UNITED STATES PATENT AND TRADEMARK OFFICE

10/617,166

Office Action Summary

DETAILED ACTION

FIG. 1A

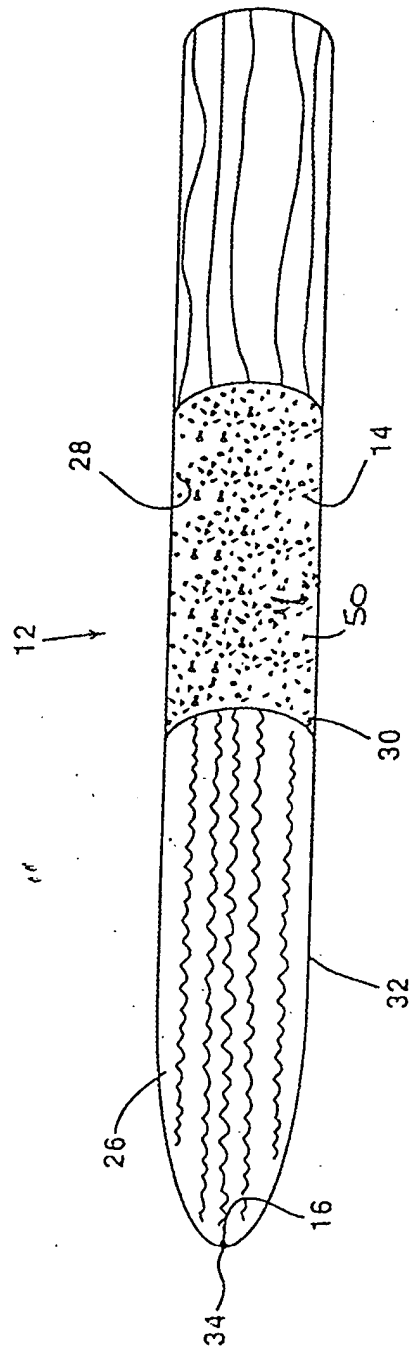
3. The drawings were received on October 3, 2006. These drawings are not accepted. The proposed drawings have an additional leader line from a new reference number 50 pointing to the medication in a dry, powdered form (Fig. 1A) or in combination with a reconstituting liquid (Fig. 1B). This appears to introduce new matter as the medication in a dry, powdered form or in combination with a reconstituting liquid is not an expelling material.
4. The drawings are objected to under 37 CFR 1.83(a). The drawings must show every feature of the invention specified in the claims. Therefore, the squeezable propellant chamber and the expelling material must be shown or the feature(s) canceled from the claim(s). No new matter should be entered.

disapproved
EKC 2 APR 2007

Corrected drawing sheets in compliance with 37 CFR 1.121(d) are required in reply to the Office action to avoid abandonment of the application. Any amended replacement drawing sheet should include all of the figures appearing on the immediate prior version of the sheet, even if only one figure is being amended. The figure or figure number of an amended drawing should not be labeled as "amended." If a drawing figure is to be canceled, the appropriate figure

FIG. 4

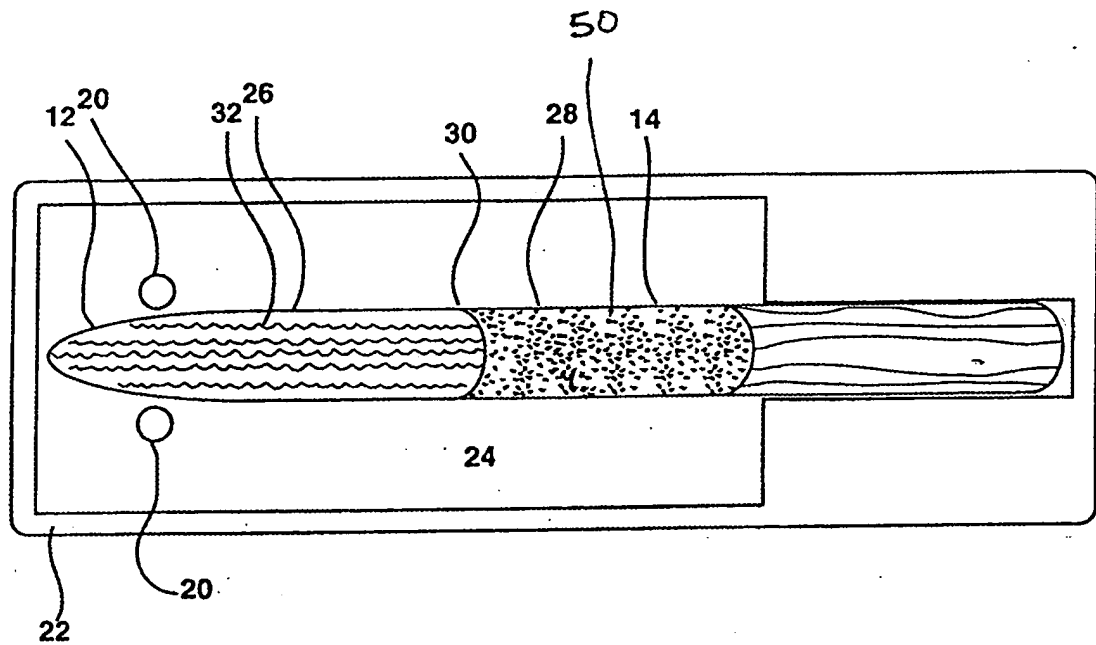
disapproved
EK 2 APR 2007
